# Technical Service Bulletin

## 94 Moisture accumulation in headlamps

94 12 98 2028277/4 November 21, 2012. Supersedes Technical Service Bulletin Group 94 number 12-91 dated October 24, 2012 for reasons listed below.

Model(s)	Year	VIN Range	Vehicle-Specific Equipment
Q7	2010 - 2014	All	Not Applicable

*Figure 2. Updated ventilation hose with integrated filter.*

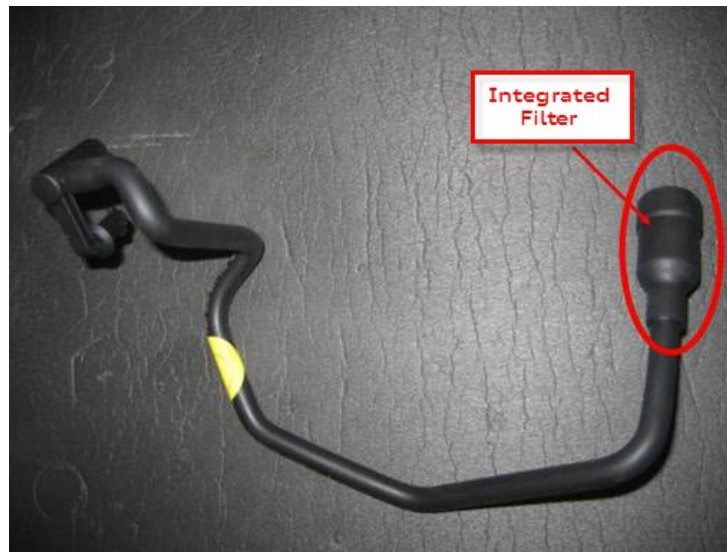
2. If vehicle's build is prior to VIN # \*CD004736, replace the headlamp ventilation hose for each headlamp with the new part number to help reduce any further humidity ingress into the headlamps (see Part information table below). Otherwise, move to step 3.

The updated ventilation hose can be recognized by the integrated filter (Figure 2).

*Figure 3. Butyl cord sealant, 10mm diameter.*

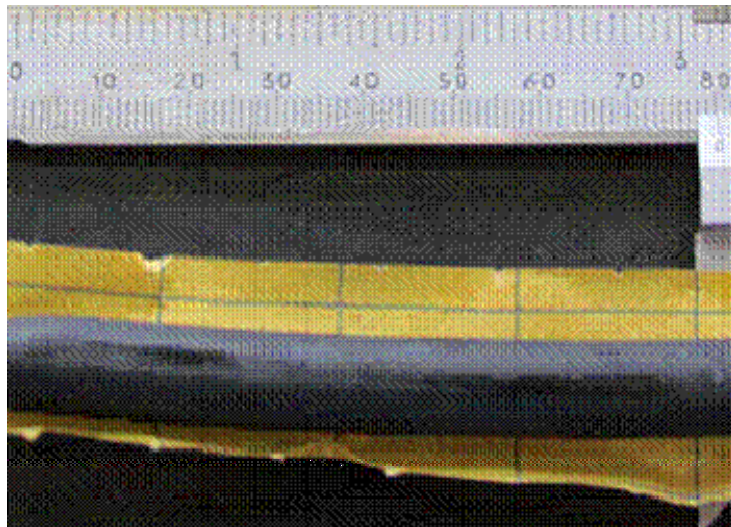
3. Cut two sections of butyl cord sealant, 8cm long each (Figure 3).

*Figure 4. Headlamp ventilation guide tube.*

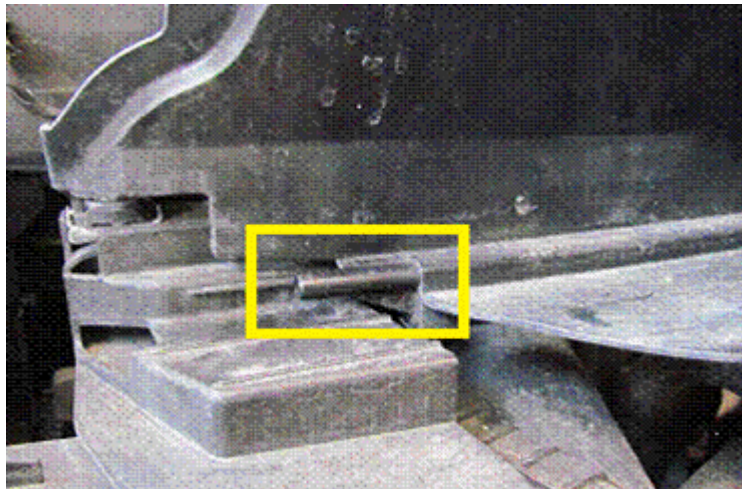
4. Each headlight ventilation guide tube must be sealed to protect against further moisture ingress (Figure 4).

*Figure 5. Initial butyl cord shown on guide tube.*

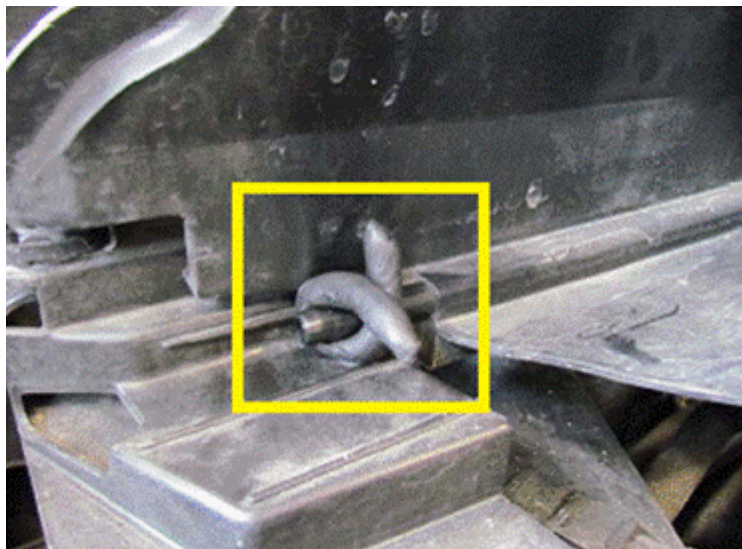
5. Wrap butyl cord sealant around the left and right ventilation tubes, taking care not to block the air passage tube (Figure 5).

*Figure 6. Butyl cord kneaded in place.*

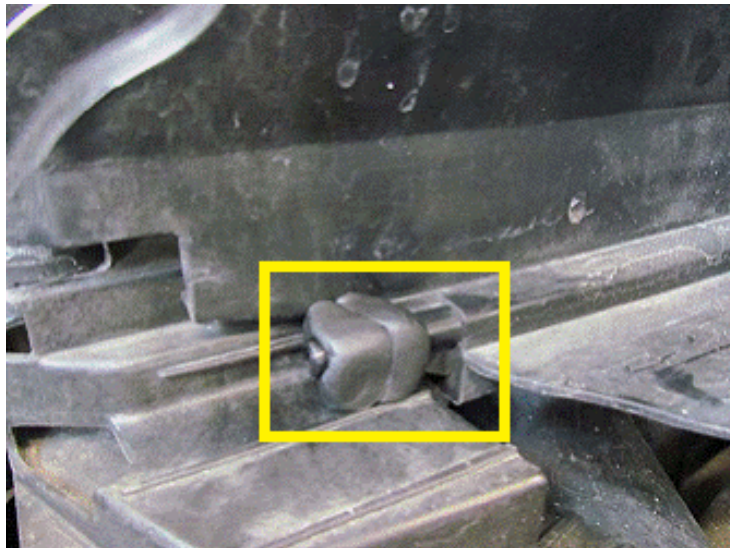
6. Knead the butyl cord sealant in place. The butyl sealant must be excessive enough so that the headlamp housing squeezes it and creates a robust seal at the housing (Figure 6).

*Figure 7. View of direction of headlamp engagement, with appropriate butyl cord application.*

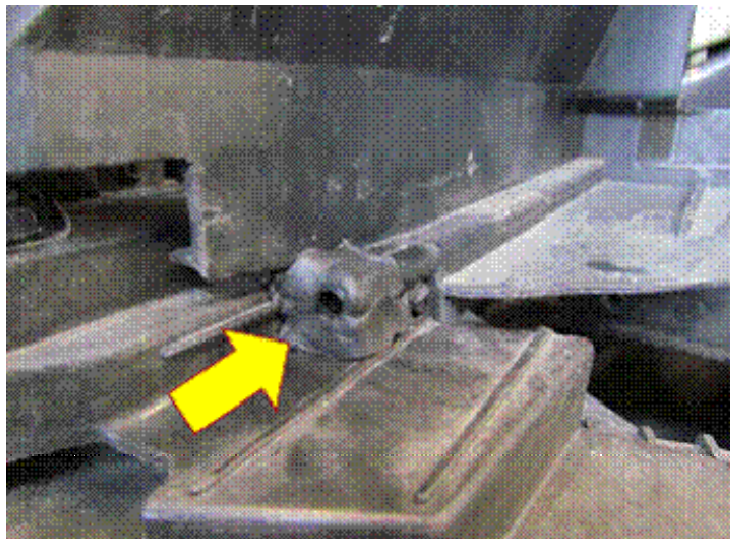
7. Leave an uncovered section of the air tube so that there is no chance the sealant will clog the air passage tube (Figure 7).
